Azim & Son (Pvt) Ltd Unit 2 (Extension)

7th February 2022

Observations

Live load Table- BNBC 2006

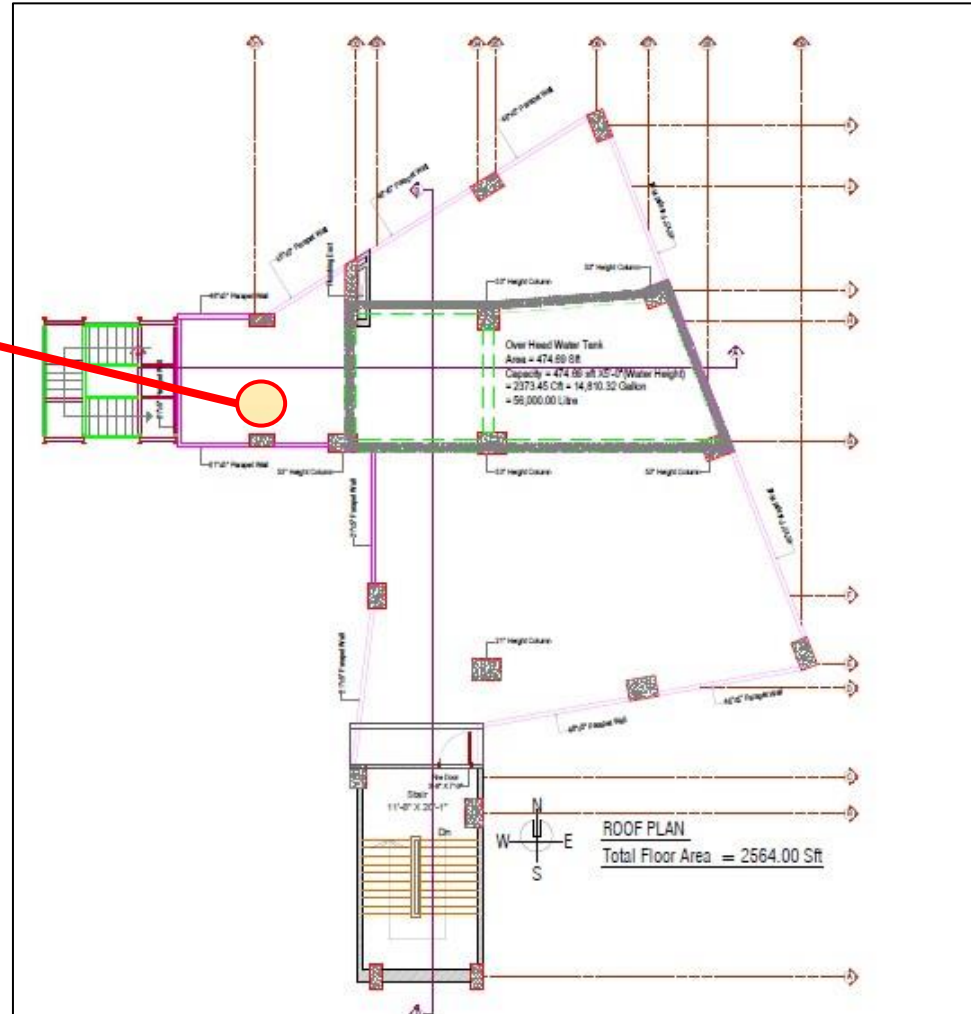
Live load consideration in Design report

As per BNBC, 6 kPa is required to consider as floor loading for the light storage facilities. During inspection, load plan was found posted considering 5 kPa at 3rd & 4th floor and 3kpa for 5th & 6th floor.

During inspection live load plan was not found as per requirement of BNBC. Factory engineer is required to revise the design report in compliance with BNBC chapter-2.

Item No.	Observation	Recommended Action Plan	Recommended Timeline
13	Design report needs to be revised (Building-5)	Produce and actively manage a loading plan for all floor plates within the factory, considering floor, column and foundation capacity.	6-weeks
14	Design report needs to be revised (Building-5)	Continue to implement loading plan.	6-months
15	Lack of as-built drawing (Steel Stair-Building-5)	Building engineer to prepare the structural drawings in compliance with section 1.9.1.2 as per BNBC.	6-weeks
16	Lack of as-built drawing (Steel Stair-Building-5)	Building engineer is required to check the lateral stability of the steel stair.	6-weeks

Roof Layout plan

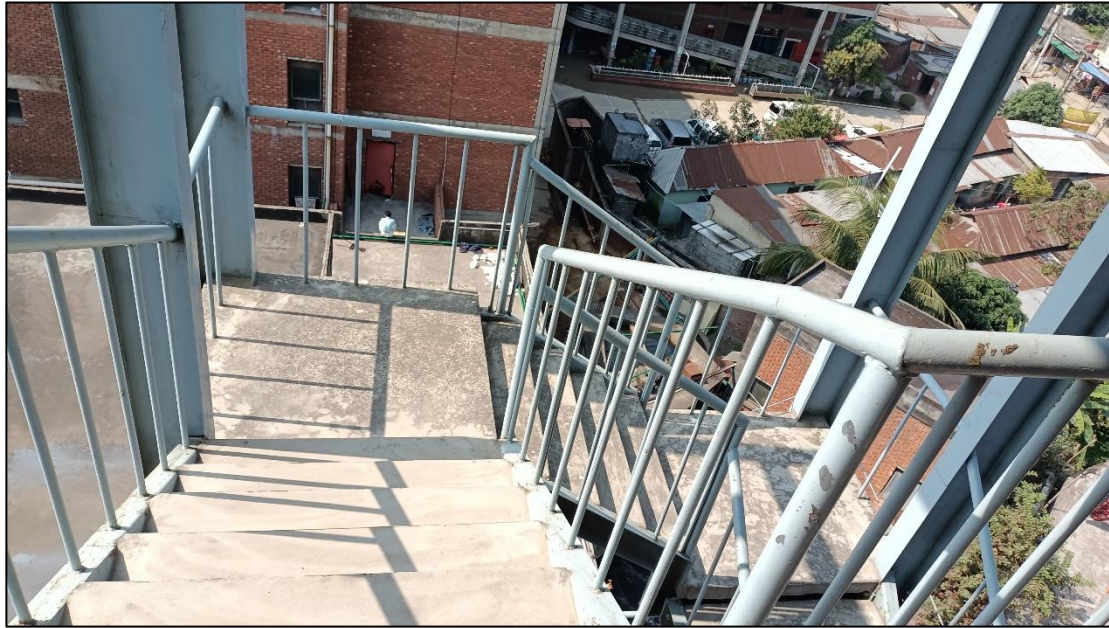
Undocumented 2000L water tank

An undocumented plastic water tank was found at roof. Factory engineer is required to survey the whole structure and update the as-built drawing. The loading from the plastic water tank is required to be considered during an adequacy check of slab.

No design report was available for Building-6

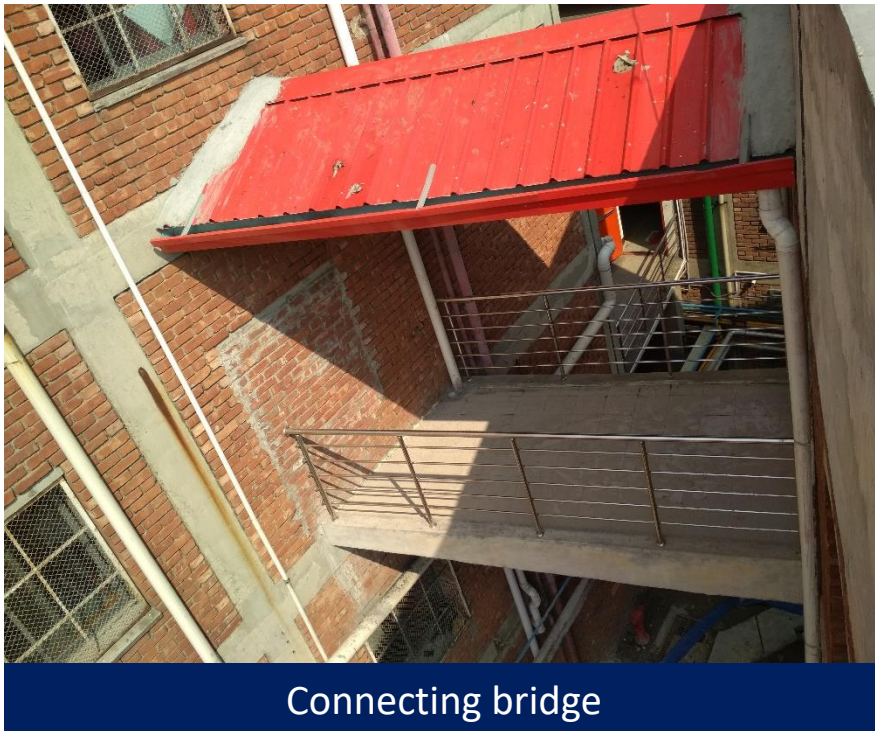
Absence of design documents

As per BNBC, every building or structure designed shall have its design documents prepared in accordance with the provision of Section 1.9.1. The design document shall include a design report, and a set of structural drawings, which shall be prepared in compliance with section 1.9.1.1 and section 1.9.1.2, part-6 of BNBC. At the time of inspection, only as-built drawing and geotechnical report were available, but no design report & load plan were available which are required to be prepared in compliance with section 1.9.1.1 (part-6, BNBC).

Item No.	Observation	Recommended Action Plan	Recommended Timeline
21	Exposed re-bar found (Building-5)	All exposed reinforcement is to be protected from corrosion which may cause degradation of the concrete.	6-weeks
22	Absence of design documents. (Building-6)	Factory engineer is required to prepare the design documents including a design report, and a set of structural drawings in compliance with section 1.9.1.1 and section 1.9.1.2, part-6 of BNBC and submit it to RSC for review.	6-weeks
23	Absence of design documents. (Building-6)	Produce and actively manage a set of floor loading plan within the factory building considering foundation, column and floor capacity.	6-weeks
24	Absence of design documents. (Building-6)	Carry out remedial works (if any) after review by RSC	6-months

Connecting bridge

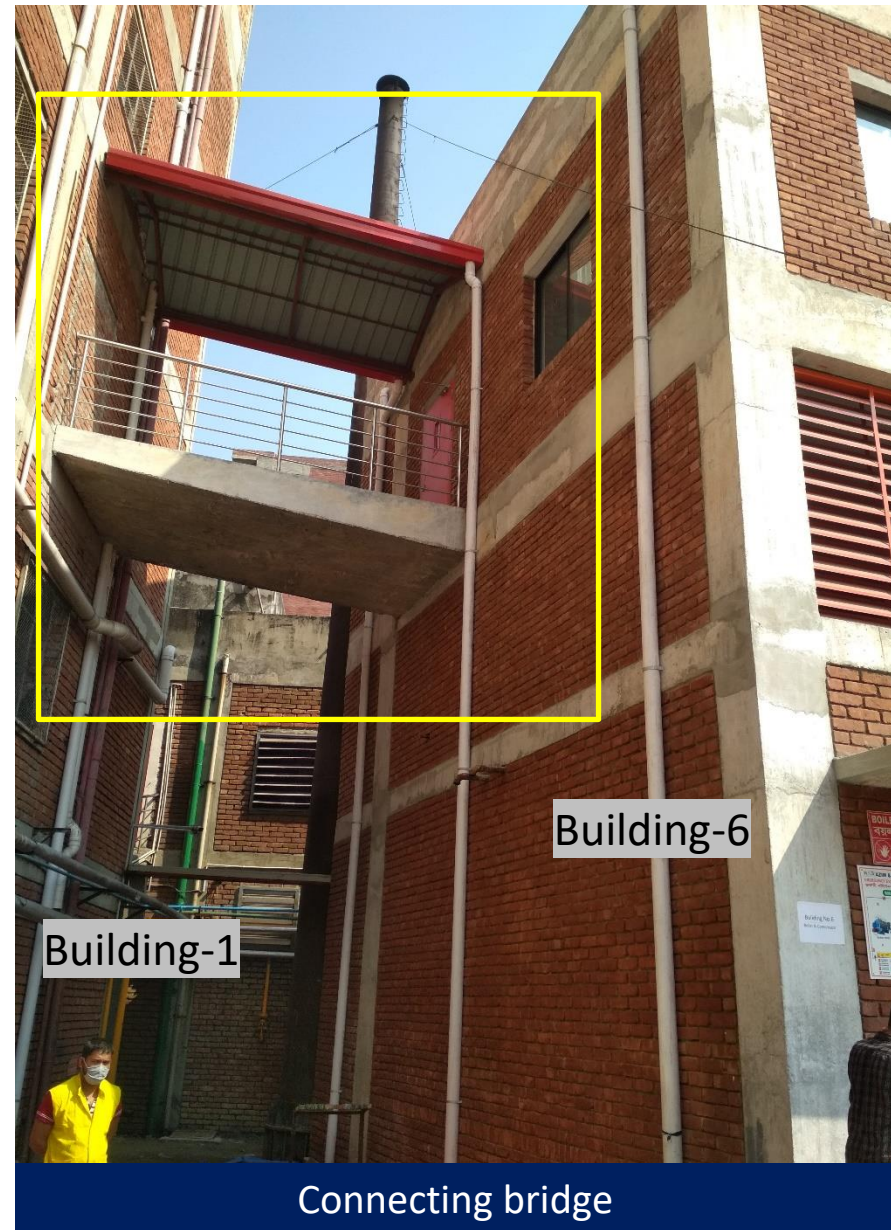
Large cantilever (connecting bridge)

At first floor of building-6 almost 4 m cantilever connection bridge was observed. The building engineer is required to check adequacy & deflection of the cantilever slab.

Item No.	Observation	Recommended Action Plan	Recommended Timeline
25	Absence of design documents. (Building-6)	Implement floor load plan.	6-months
26	Large cantilever (connecting bridge). (Building-6)	Building engineer is required to check the adequacy & deflection limit of the cantilever slab.	6-weeks
27	Large cantilever (connecting bridge). (Building-6)	Implement any remediation work if required.	6-months
